Millstone Nuclear Power Station, Unit No. 3
Response to Request for Additional Information
Inservice Inspection Program

Millstone Nuclear Power Station, Unit No. 3
Response to Request for Additional Information
Inservice Inspection Program

Relief Request: IR-1, Rev. 3

FIGURE 1A

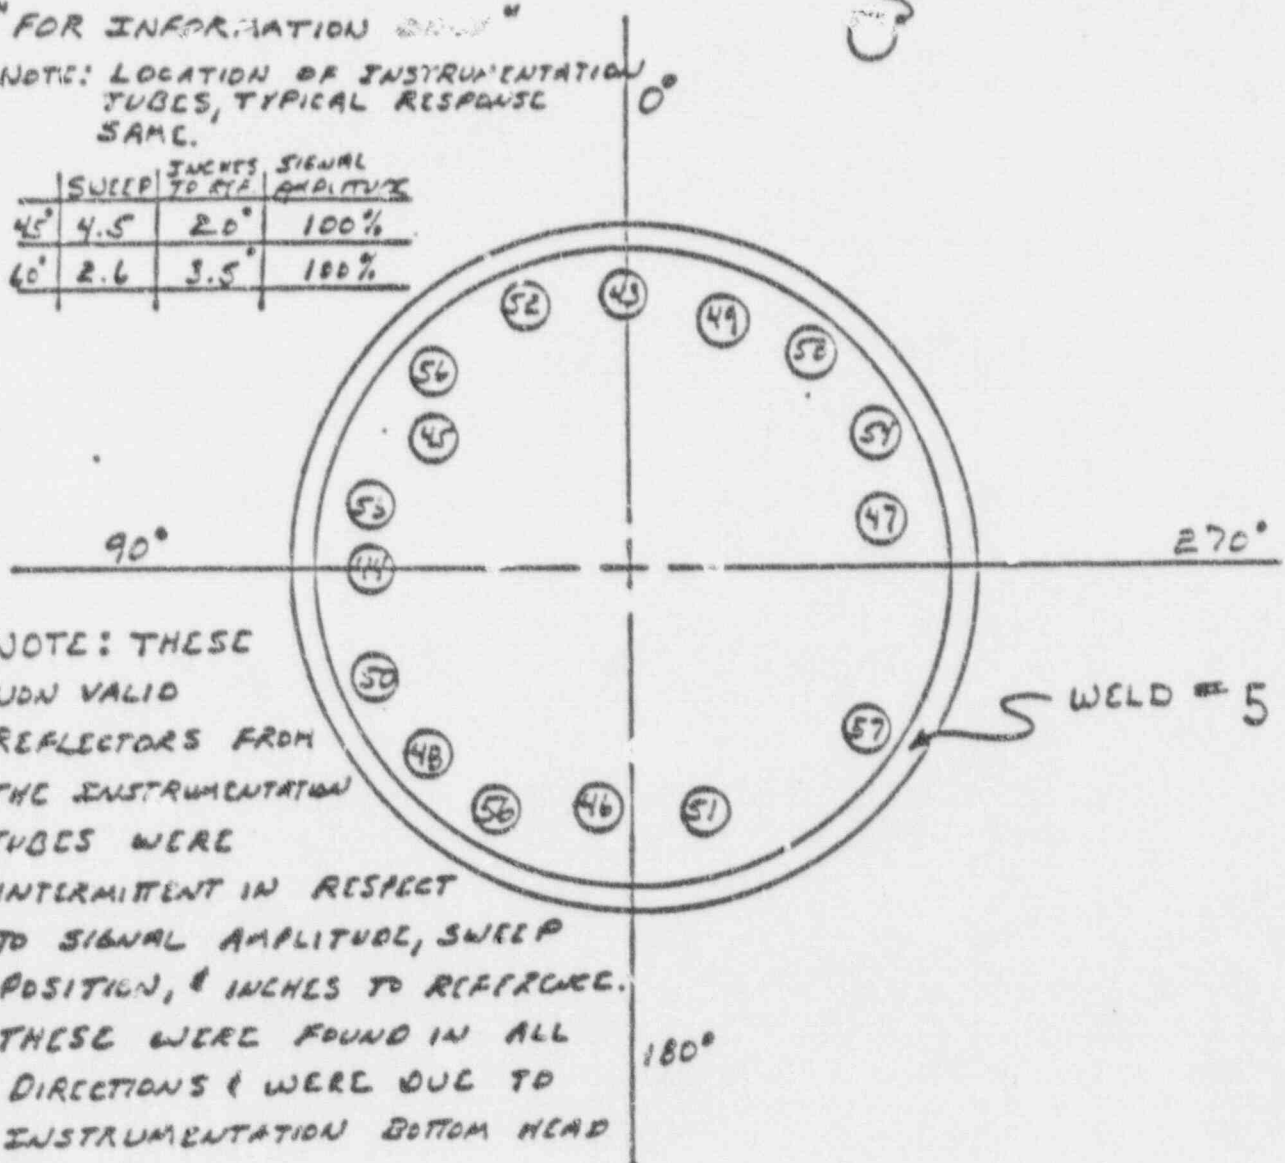
Question: Request for Relief IR-1 (Revision 2): Regarding the welds where a manual examination from the OD is "suggested"; will the manual examination be performed? On Weld #5 (torus/dollar plate), the drawing depicts the inspection tool as clearing instrument nozzles. Why can't a partial examination from the ID be performed? Other utilities have performed partial exams of these welds, how does Millstone 3 differ?

Response: Relief Request IR-1 has been revised and is attached. Request for relief is being withdrawn for welds 5, 15, 16, 17 and 18. Based on preservice inspection results, a remote (ID) UT Examination encountered major interferences from the instrument nozzles. It is understood that NNECO will investigate any advances in RPV tooling to address the inaccessibilities noted during PSI. Based on inspection results, inservice, it will be determined if a supplementary manual ultrasonic examination can be performed (an ALARA review will determine if this is feasible) or a request for Relief of the inaccessible areas will be submitted.

FIGURE 3

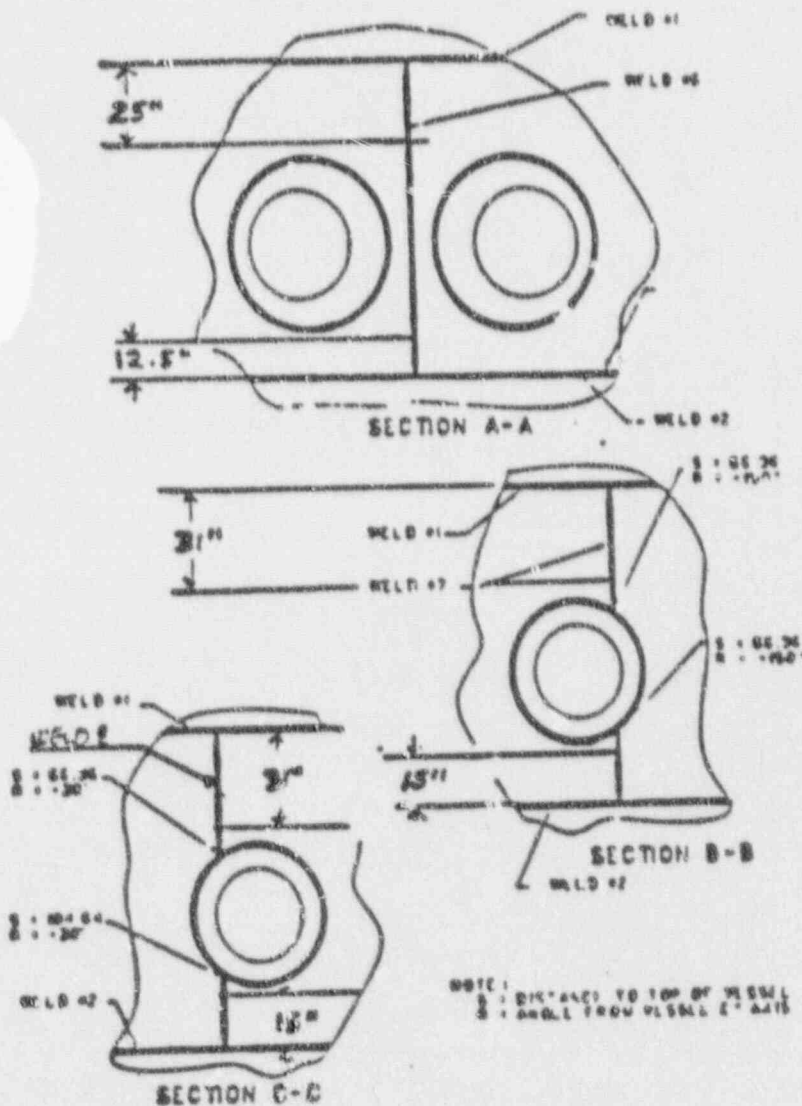
ITEM NO.	WELD NO./DESCRIPTION	MANUAL	REMOTE	COMMENTS
B1.21	#4 Lower Shell to Lower Head	N/A	Core Lugs	<p>A. This weld is 100% accessible from the lower head side. Examined with 45° and 60° axially [one direction] and circumferentially [both directions].</p> <p>B. This weld is 70% accessible from the lower shell side. Examined axially and circumferentially. Six core lugs occupying a total of about 17° each preclude four directional examination of about 153° of weld 4 as examined from the lower shell side. See Figure 2A.</p> <p>NOTE: Core lug obstructions are considered normal in the in-service examination of lower shell to lower head welds from the shell side. No special considerations are necessary for future examinations other than an estimate of the examination not practical from both directions due to restrictions.</p>
B1.12	Welds 6, 7, and 8 Upper shell long.	N/A	Normal nozzle geometry (major limitation)	ISI will be conducted to maximum extent practical (reference Figure 3). Will be examined similarly at the end of the first interval.
